**SUNDRY NOTICES AND REPORTS ON WELLS**  
*Do not use this form for proposals to drill or to re-enter an abandoned well. Use form 3160-3 (APD) for such proposals.*

8. Well Name and No.  
HAMMOND 17 FED 1

PLEASE SEE ATTACHED P&A PROCEDURE. APACHE PROPOSES TO PLUG AND ABANDON THIS WELL WITH TH ATTACHED PROCEDURE.

**\*\* BLM REVISED \*\* BLM REVISED \*\* BLM REVISED \*\* BLM REVISED \*\* BLM REVISED \*\***

#2

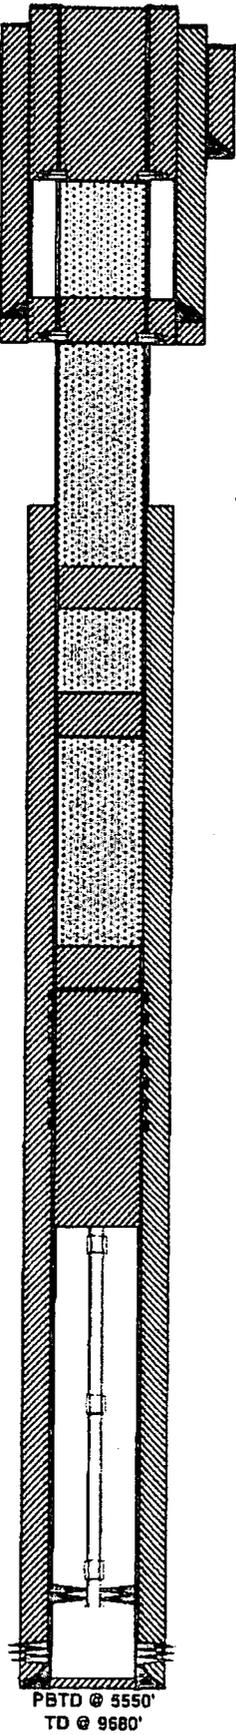
*optional of Perf @ 200 sqz cmt Surf.*

Surf. Original AAD.  
 Changed to  
 17 1/2" Hole  
 13 3/8" 48# @ 550'  
 w/ 750 sx to surf  
 Never set.
